# Value Engineering Study

### RECONSTRUCTION OF US 460 PIKE COUNTY, KENTUCKY PHASE II

### SECTIONS 7 THROUGH 9V

Kentucky Transportation Cabinet  
Division of Transportation Planning  
Frankfort, Kentucky

## SKETCH OF RECOMMENDED DESIGN

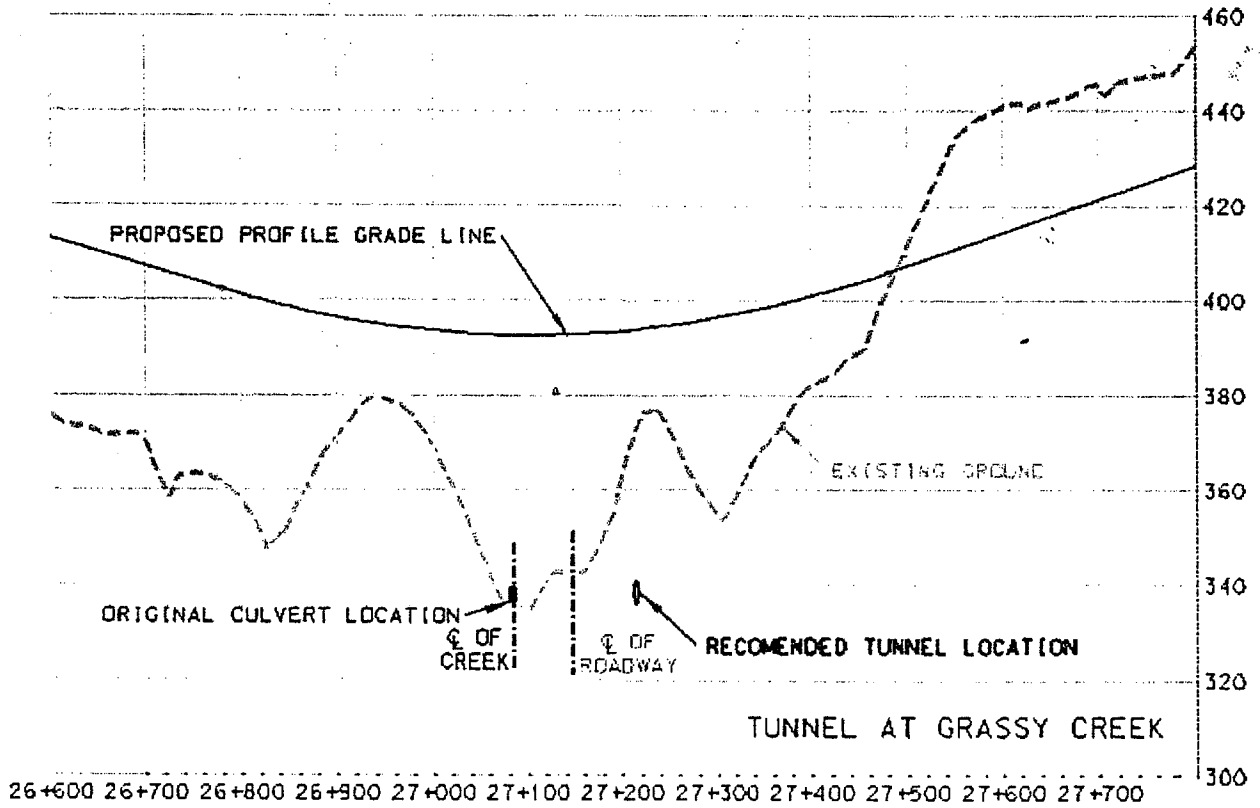
DESCRIPTIVE TITLE OF RECOMMENDATION: Build Tunnel at Grassy Creek

The original design calls for the construction of a 20' by 12' box culvert, 1280 feet (390 meters) in length, to carry Grassy Creek beneath the proposed roadway embankment.

Eliminate the proposed box culvert and replace with a 400 meter tunnel through the adjacent hillside. This alternative will also require 245 feet of channel realignment and a 15 meter box culvert under shallow fill.

Since the cost of a culvert under approximately 55m of fill is relatively costly, replacing the culvert with a drilled tunnel will substantially reduce the cost of spanning the Grassy Creek.

RECOMMENDED TYPICAL SECTION  
BIFURCATED ALIGNMENT

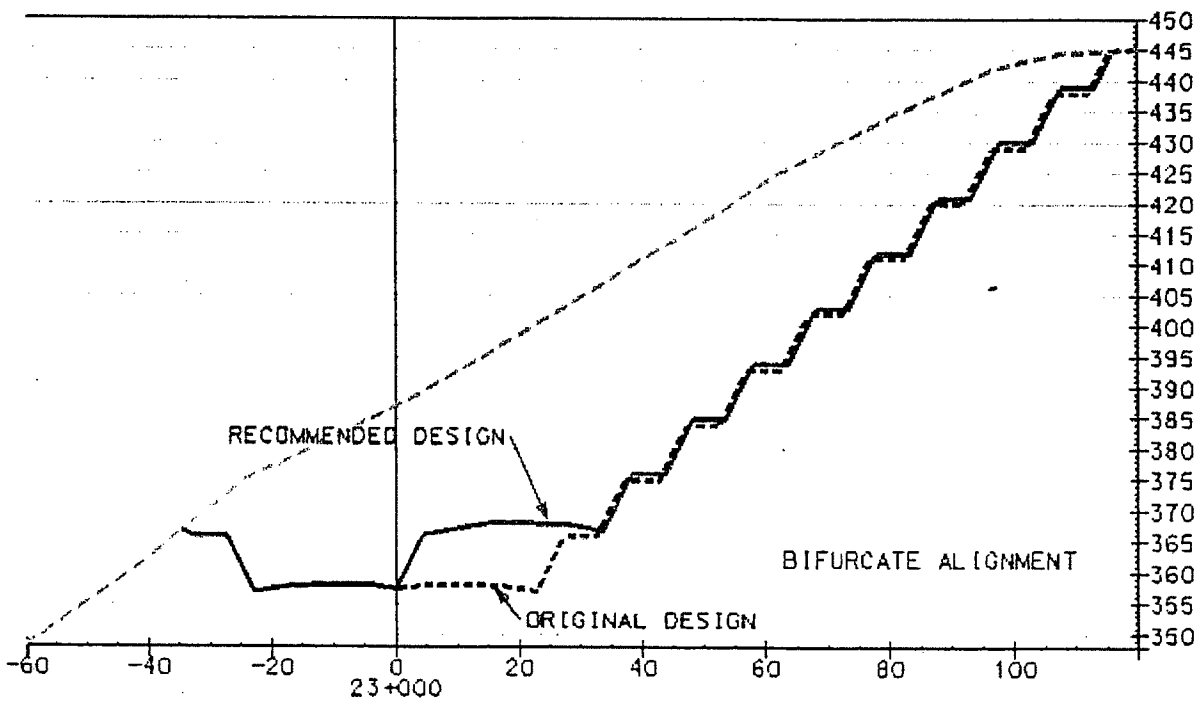
Bifurcate east and west bound lanes, making one roadway higher than the other, and thereby reducing the excavation quantity.

Between stations 22 + 225 to station 24 + 875 and station 26 + 740 to station 28 + 960, we propose raising the grade of the right (eastbound) lanes, approximately 10 meters but parallel to the 7.000% grade segment, in two different areas. Area one is from station 22 + 650 to station 24 + 575. Area two runs from station 27 + 130 to station 28 + 460 +/- . This would raise the eastbound lanes and reduce excavation cost. This recommendation will reduce the excavation quantity by approximately 1,800,000 Cubic Meters. There may be other areas where this bifurcation feature would apply. However, due to the relatively short time frame allowed for the VE study, only two areas were analyzed.

## SKETCH OF ORIGINAL AND RECOMMENDED DESIGN

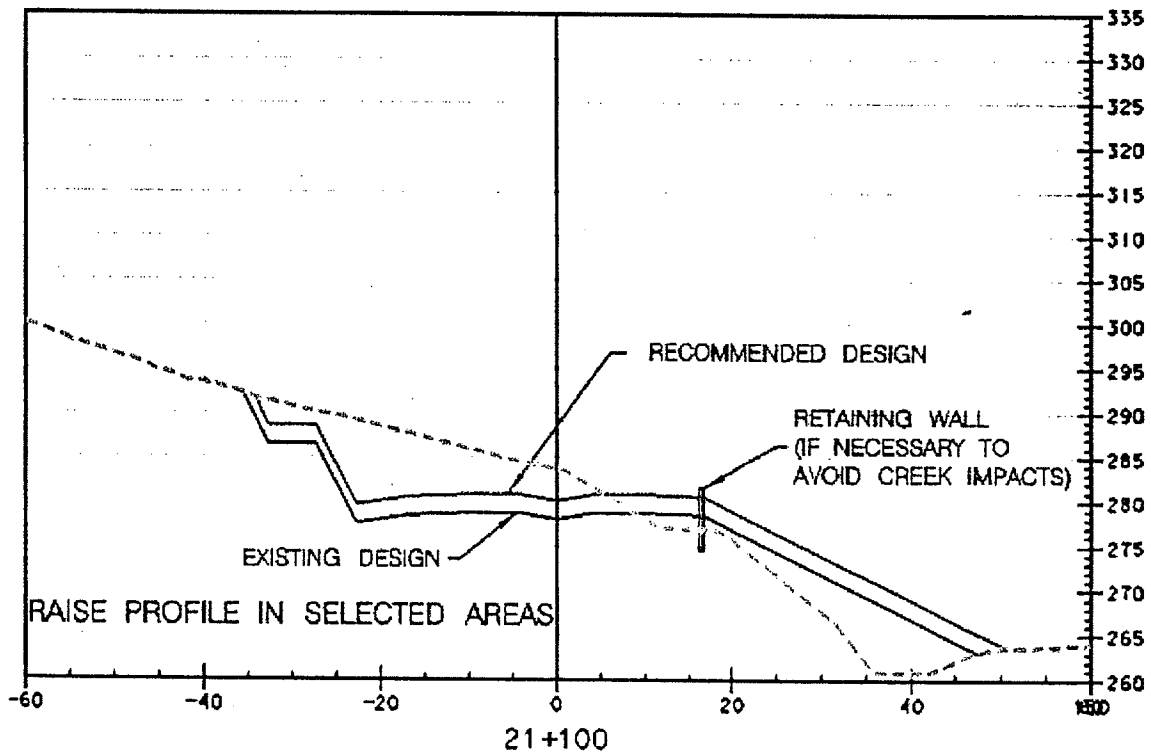
Raise profile by approximately 2.0 m between stations 20 + 400 and 24 + 500, and by approximately 5-6 m between stations 24 + 500 and 26 + 100, and by 2.0 - 2.5 m between stations 26 + 450 and 28 + 960.

Provides \$6.97 million in potential savings in excavation and reduces waste by approximately 3.5 million cubic meters without adversely affecting drainage and profile.

TYPICAL SECTION  
Barrier Median

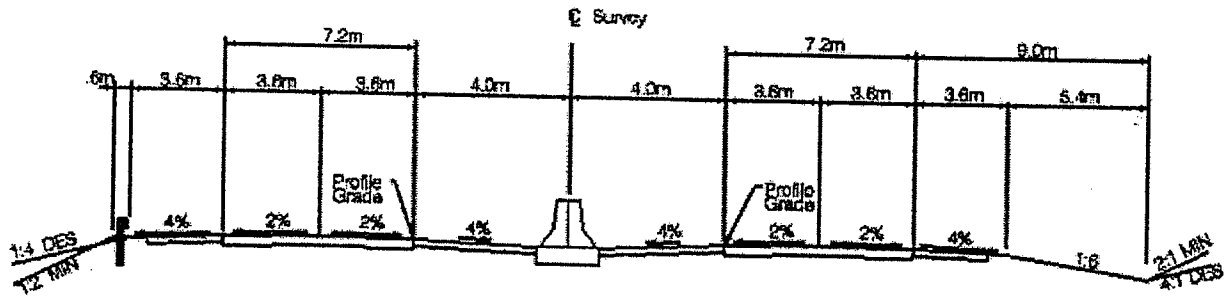
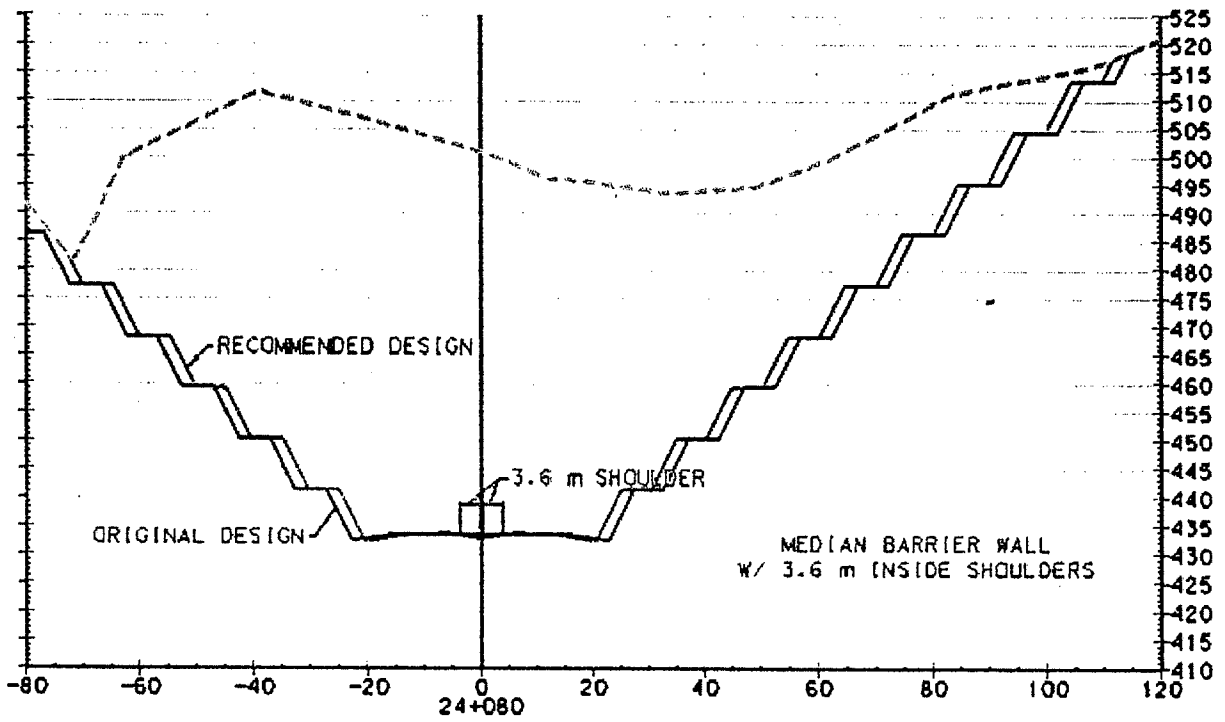
Original design has 12 meter median with 1.2 meter paved shoulder adjacent to left driving lane. The median is depressed on 1:6 slope. The unpaved portion of median is turf.

Recommended change is 8 meter median with 1.2 meter paved shoulder adjacent to left driving lane. The median will be separated with concrete barrier wall. Remaining shoulder in front of barrier median will be paved with DGA. This revised section in proposed is major cut areas and will require crash cushions at transition to fill sections.

Using barrier wall in major cut areas reduces excavation by 981,000 cubic meters. 5500 meters of barrier wall with crash cushion and 9400 metric ton of DGA will be needed. Net savings is \$2,200,000.

## SKETCH OF ORIGINAL AND RECOMMENDED DESIGN

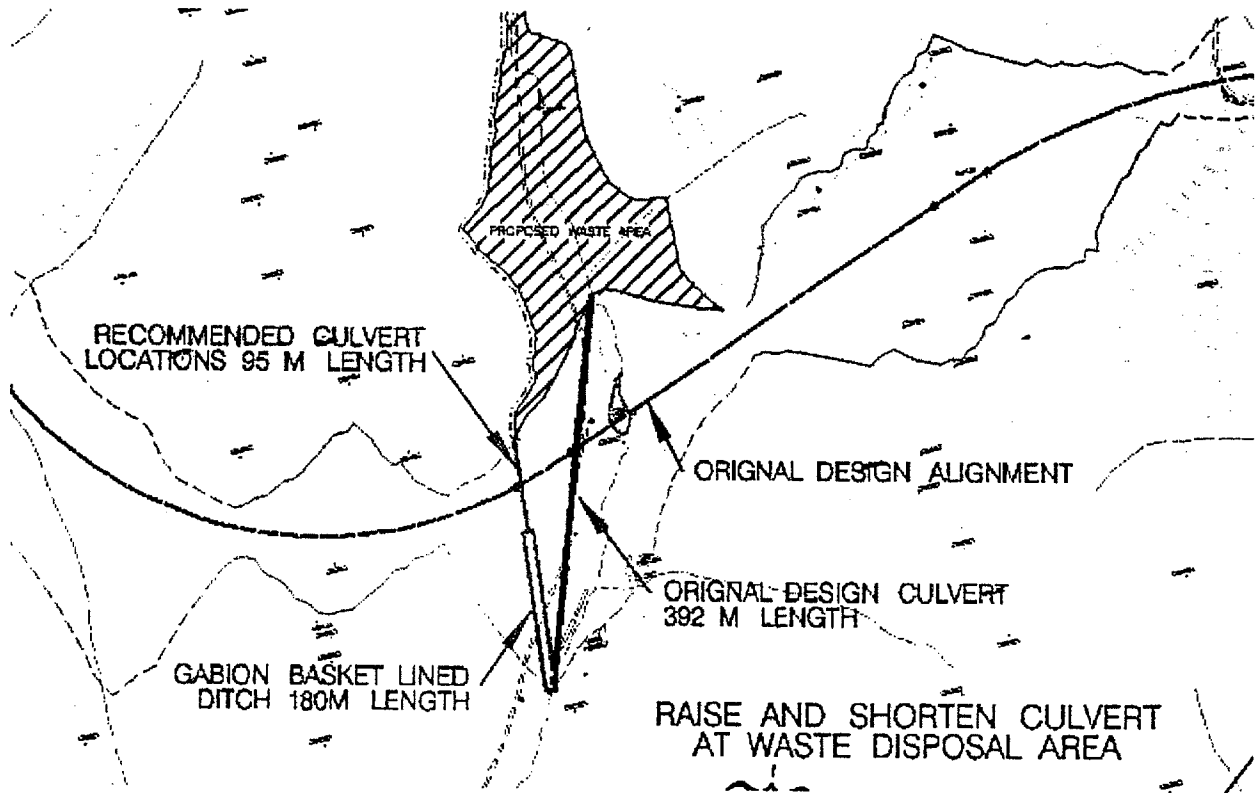
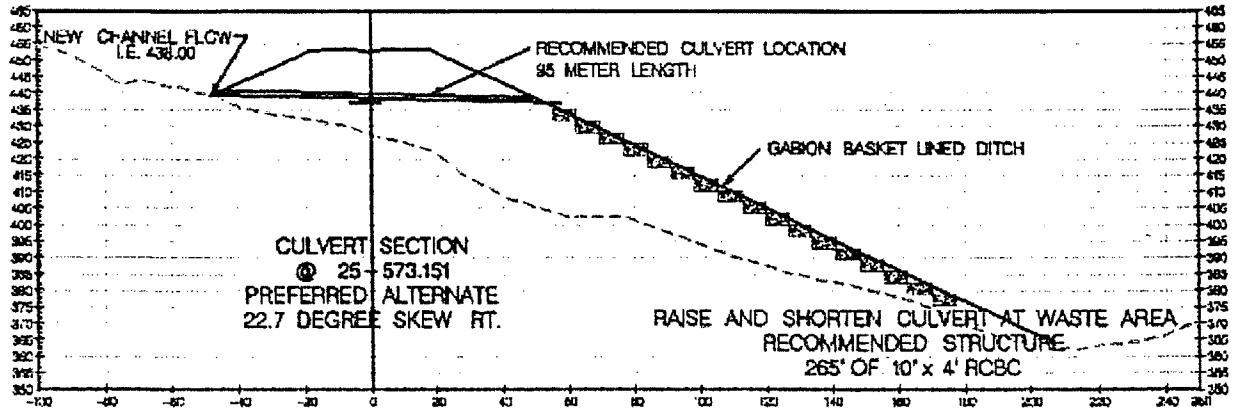
Culvert located in natural stream bed with approximately 61 meters (200 feet) of fill in hollow.

The area on the inlet (North) side of the culvert will be used as a waste area, raising the ground elevation to 440+/- (metric). Due to the filling in this area, the channel will require realignment. An energy dissipater will be required at the outlet of the culvert to handle the drop discharge. This realignment will offer the opportunity to construct the culvert at a significantly higher elevation within the embankment allowing it to be shortened.

The area on the left or north side of this culvert will be used for a waste area. This hollow will be filled, thus raising the stream flow line. This will allow the culvert to be raised and shortened. The original design cost of \$768,000 per 1280 feet of Box Culvert gave a price of \$600.00 per linear foot of Box. The savings will be reduced because an energy dissipating device will be required at the outlet end of the raised culvert. Waste embankment is proposed to elevation 440+/- (metric) on the culvert entrance end. The new raised culvert will be 95 meters long, thus saving \$657,750. However, we estimate the cost of the energy dissipating device at \$133,920. The results in a net savings of \$522,750 for value engineering recommendation #5.
